CARRIAGE MEADOWS SOUTH AT LORSON RANCH FILING 2

**CARRIAGE MEADOWS SOUTH
 AT LORSON RANCH
 FILING NO. 2**
 El Paso County, Colorado
 PUD & PRELIMINARY PLAN

PCD FILE NO.: PUDSP-18-5

SITE PLAN
P4 OF

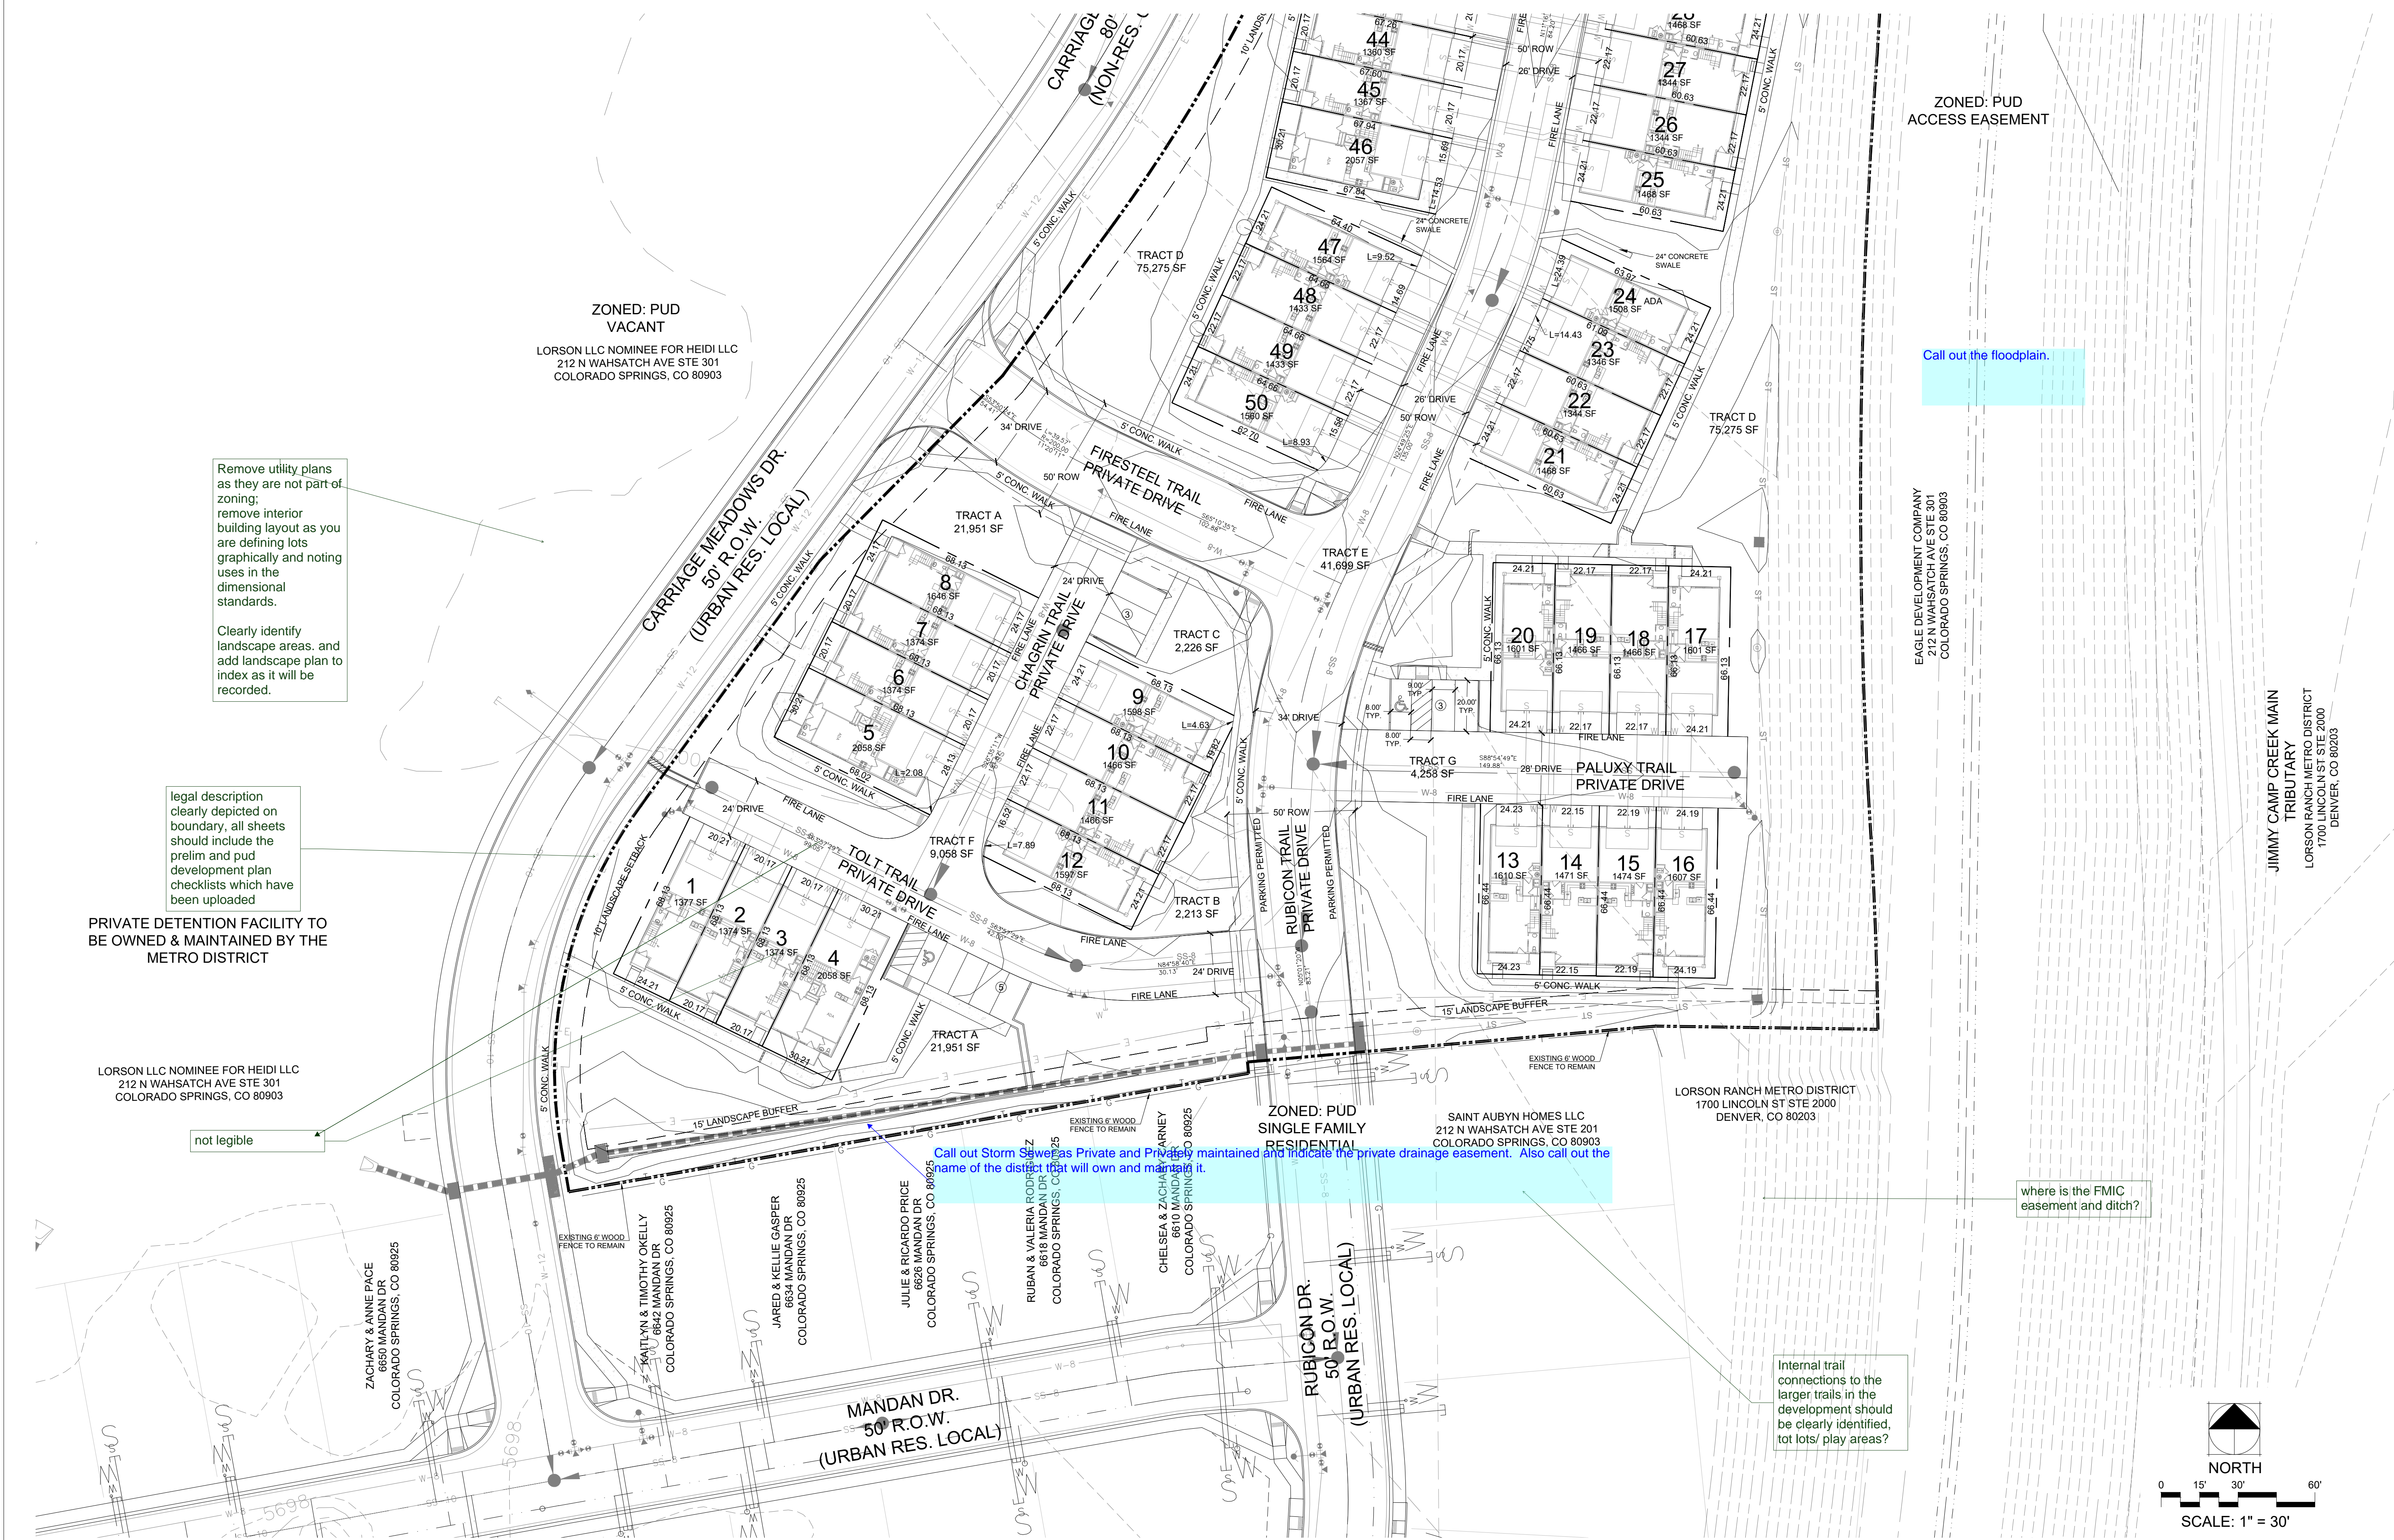
Remove utility plans as they are not part of zoning; remove interior building layout as you are defining lots graphically and noting uses in the dimensional standards.
 Clearly identify landscape areas, and add landscape plan to index as it will be recorded.

legal description clearly depicted on boundary, all sheets should include the prelim and pud development plan checklists which have been uploaded

not legible

Call out Storm Sewer as Private and Private to be maintained and indicate the private drainage easement. Also call out the name of the district that will own and maintain it.

Call out the floodplain.

where is the FMIC easement and ditch?

Internal trail connections to the larger trails in the development should be clearly identified, tot lots/ play areas?

is this Utilities?
